1 REDLINE REVISION 3/26/10

MD 187 (OLD GEORGETOWN RD) AND EXECUTIVE BLVD

TRAFFIC SIGNAL PLAN

TS NO. 4382B | DRAWING NO. 1 OF 2 | SHEET NO. OF

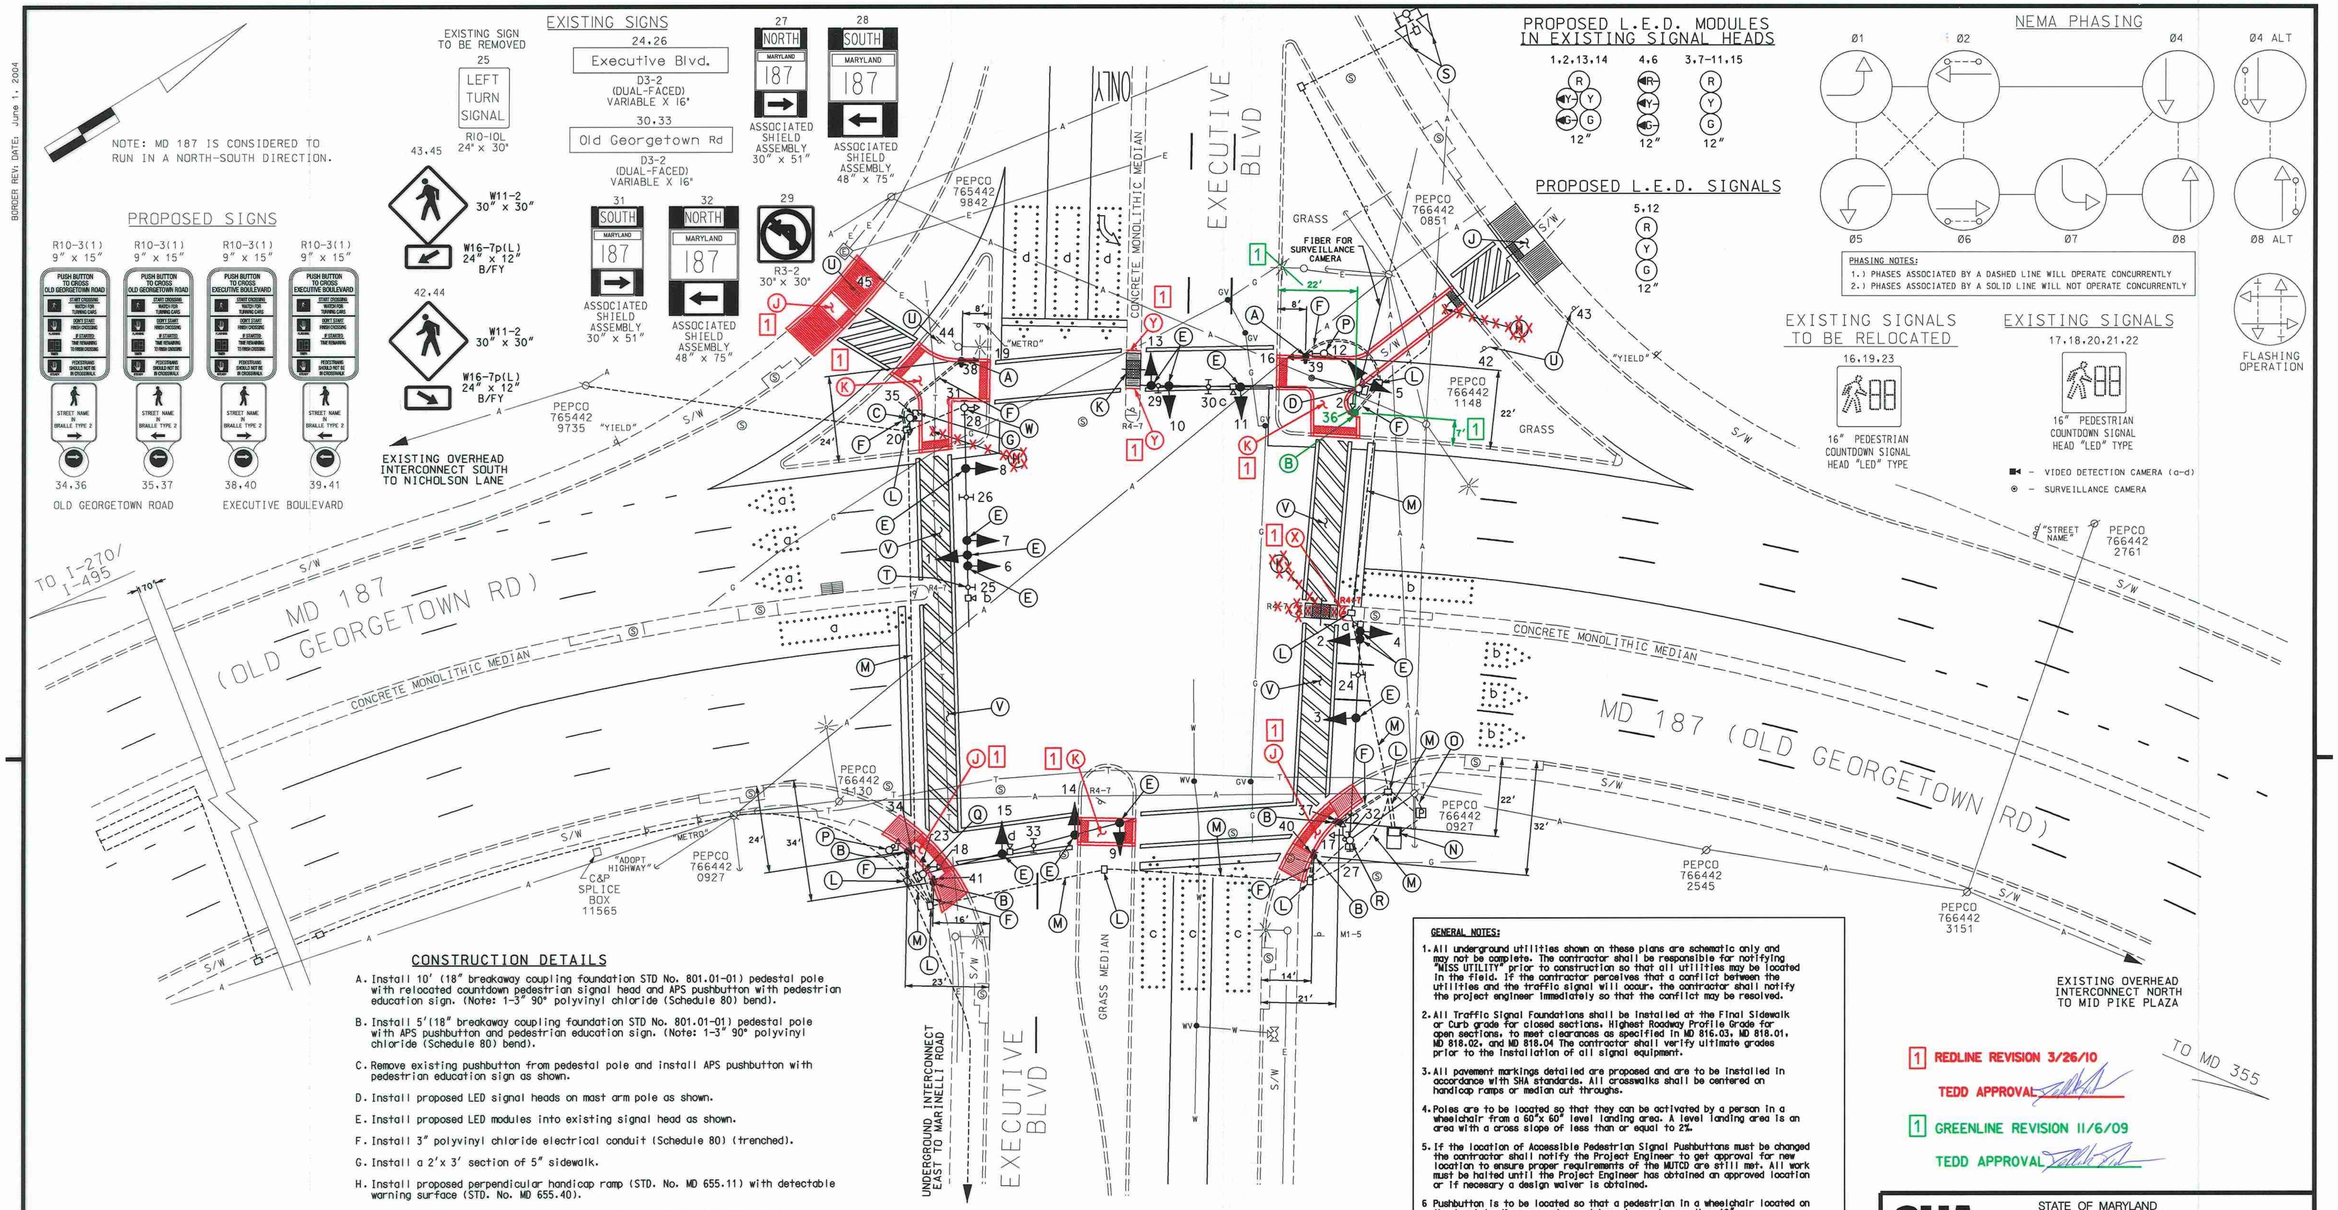
1 X. Cut back median nose and install proposed sign on wood support as shown.

1 Y. Insall curb as shown.

1 GREENLINE REVISION 11/6/09
